Replacing Pin on Power Distributor if the Power Distributor is Responsible for the Fault (41/14)

Vehicle Type: **All 911 Carrera models (997)**
All Boxster/Cayman models (987)

Model Year: **As of 2005 up to 2012**

Installation position of power distributor

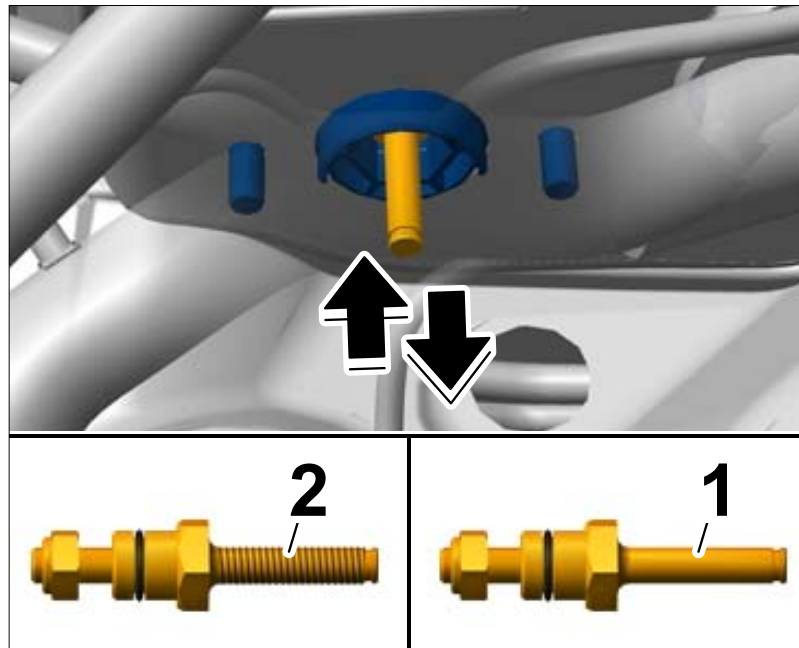
Information: **In the event of complaints relating to the overall power supply on the vehicle and if a "corroded pin in the power distributor" is determined as the cause of the problem, the pin (⇒ *Item 1 is old style*) must be replaced.**

Item 1 is old style

Action Required: Replace the pin with a **new, modified pin (item 2)**, see Workshop Manual ⇒ *Workshop Manual '978955 Replacing pins on the power distributor with screw bolts'*.

Parts Info: **997.612.908.00 – NEW** – ⇒ Repair kit containing: B+ line – pin with O-ring (sealing ring) – shrink-fit hose and mounting parts.
